SUBJECT: Change Proposal PE-22, Timer Access
and Cover

COMPANY NAME Perkin-Elmer Corp.		ENGINEERING STUDY <input type="checkbox"/>		CHANGE PROPOSAL <input checked="" type="checkbox"/>		Proposal No. P-E-22				
DATE Feb. 22, 1962		AFFECTS: WSPO <input checked="" type="checkbox"/>		PROJECT <input type="checkbox"/>						
NAME OF MAJOR COMPONENT Tracker		PART OR LOWEST SUBASSEMBLY Front Cover Assy.		PART NO. & MODEL OR TYPE P/N 151-0114						
TITLE OF PROPOSAL: Timer Access and Cover										
NATURE OF PROPOSAL: Modification of P/N 151-0114 Front Cover Assy. to provide a 2-3/4" access hole and a light-tight quick disconnect cover.										
REASON FOR PROPOSAL: To facilitate timer access for "Hacking". REF: Suggestion LAU-49-61M dated 11 April 1961 NOTE: Deviation from suggestion required to: 1. Insure Tracker cover rigidity at access hole. 2. Provide greater rigidity to proposed access cover. 3. Provide more positive "Light-Proofing".										
E S		ESTIMATED COST AND TIME INVOLVED: ADDITIONAL FUNDING REQUIRED: N/A

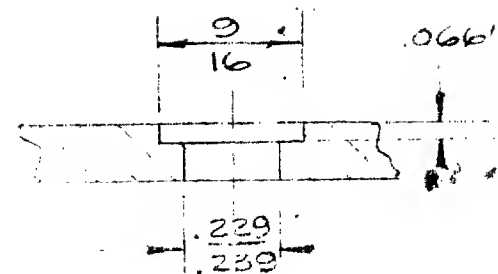
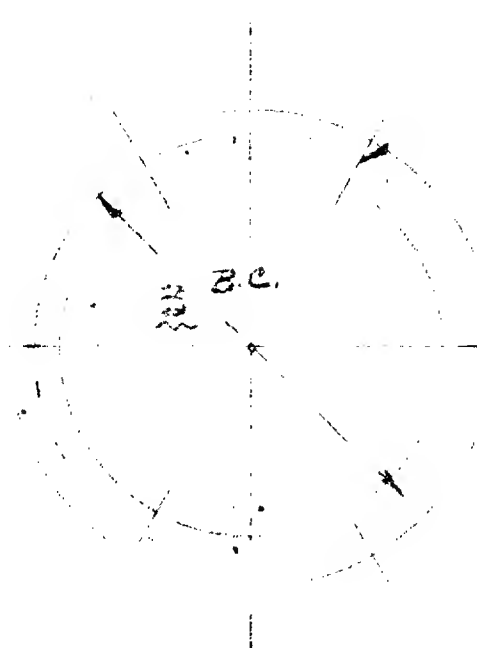
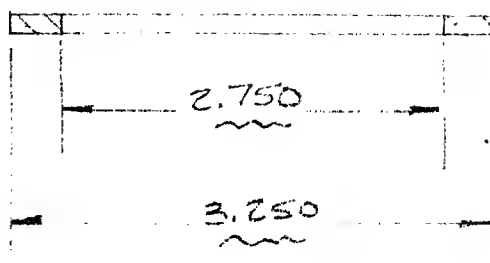
C P		ESTIMATED COST FOR KITS OR PARTS: \$60.00/kit (including 2 sets of tools) ADDITIONAL FUNDING REQUIRED:								
ITEMS AFFECTED BY PROPOSAL: P/N 151-0114 Cover Assy.										
Safety <input type="checkbox"/>	Mission Effectiveness <input type="checkbox"/>	Performance <input type="checkbox"/>	Operating Procedure <input checked="" type="checkbox"/>	Interchangeability <input type="checkbox"/>	Weight or Weight & Balance <input type="checkbox"/>	Tools & Support Equipment <input type="checkbox"/>	Maintenance Procedure <input type="checkbox"/>	Service Life <input type="checkbox"/>	Flight Manual <input type="checkbox"/>	Maintenance Manual <input type="checkbox"/>
EST. MAN/HR. REQ'D. TO ACCOMPLISH CHANGE IN FIELD 1 Hr.										
SOURCE OF PARTS FOR KIT contractor				AVAILABILITY 6-8 WEEKS AFTER APPROVAL						
DISPOSITION OF SPARES AFFECTED N/A				STATINTL <input type="checkbox"/>						
INITIATED BY: customer Approved LAU-49-61M 2002/06/14 : CIA-RDP71B00697R001600050033-1				APPROVED: WSPO <input type="checkbox"/>
